Change Number	APPROVED DOCUMENT CHANGE CONTROL FORM Do not use blue ink. Type, or print in black	Date October 16, 1990
Document Number & Title DOE-RL 88-32, Rev. 1, "Remedial Investigation/Feasibility Study Work Plan for the 200-BP-1 Operable Unit, Hanford Site, Richland, Washington"		Date Document Last Issued March 1990
Originator M. A. Buckmaster <i>M.A. Buckmaster</i> 200-BP-1 RI Coordinator <i>10/16/90</i>		Phone 376-1792
<b>Description of Change</b> <p>Modify text to indicate wells installed in the Rattlesnake Ridge Interbed will be completed in the first water producing zone. The first water producing zone will be identified by bailing the borehole and monitoring water levels during drilling of the Elephant Mountain Basalt flow bottom and the Rattlesnake Ridge Interbed. Additionally, examination of geologic samples obtained during drilling of these stratigraphic intervals will be used as a tool to identify potential producing zones. The length of screens set in the Rattlesnake Ridge Interbed shall not exceed 15 feet but may be less depending upon the encountered stratigraphy.</p> <p>Note: Include affected page number Pg WP-155, SAP/FSP-35</p>

## WELL COMPLETION STRATEGY FOR

Idealized Completion of Well 699-49-57B

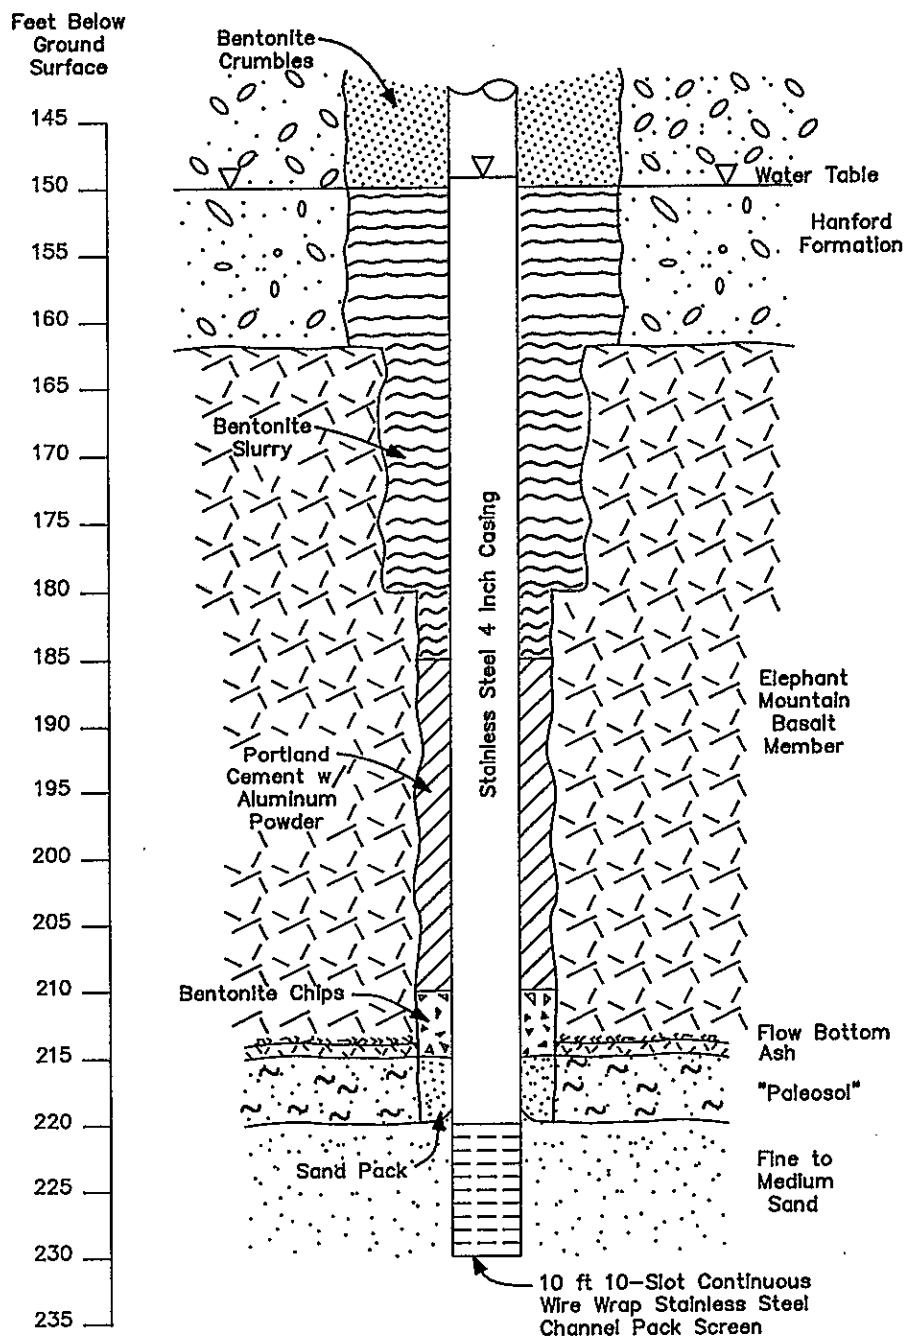
<b>Justification and Impacts of Change</b> <p>The current workplan strategy for well completion dictates that the screen extend from five feet into the overlying basalt to 15 feet into the upper portion of the Rattlesnake Ridge Interbed (total screen length of 20 feet). This strategy is undesirable for the following reasons: 1) screen lengths greater than 15 feet are in direct violation of the generic well specification for deep confined wells as stipulated in WHC-S-014, Rev. 4. 2) The basalt flow bottom and uppermost section of the Rattlesnake Ridge Interbed may not represent a suitable monitoring zone if these units do not produce water.</p> <p>(continued)</p>		
<i>J. K. Erickson</i> J. K. Erickson		<u>10/17/90</u>
DOE UNIT MANAGER <i>Douglas H. Sherwood</i> D. Sherwood		DATE <u>10/18/90</u>
LEAD REGULATORY UNIT MANAGER		DATE
Per Action Plan for Implementation of the Hanford Consent Order and Compliance Agreement, Section 9.3

As a result, it is expedient to identify the first water producing zone and construct the well so as to monitor the uppermost 5-15 feet of that producing zone. This change will permit the monitoring of the proper hydrogeologic zone. As a result, this change will not adversely impact the ability of wells installed in the Rattlesnake Ridge Interbed to meet the data objectives stipulated in the workplan.

Hydrogeologic information obtained upon penetration of the Rattlesnake Ridge Interbed in borehole 699-49-57B indicates that the basalt flow bottom is thin (one to two feet thick) and produces little (if any) water. Upon penetration of the flow bottom, a split tube sampler was driven for TOC samples and lithologic description. The lithology encountered immediately below the basalt included a 12 inch thick "baked" ash unit and a 2-3 feet thick indurated paleosol. Neither the ash or paleosol units produced noticeable volumes of water while drilling. Below the paleosol, a fine to medium grained unconsolidated sand body was penetrated. The borehole was extended approximately 10 feet into the sand body. While drilling the sand body, water levels in the borehole increased to approximately the same level as the static water level in the unconfined aquifer, indicating that a significant water producing zone had been penetrated.

The well screen for 699-49-57B will be installed in the fine to medium grained sand body below the paleosol unit. This sand body represents the first significant water producing zone in the Rattlesnake Ridge Interbed encountered in this borehole. The attached figure depicts the idealized completion strategy for borehole 699-49-57B.
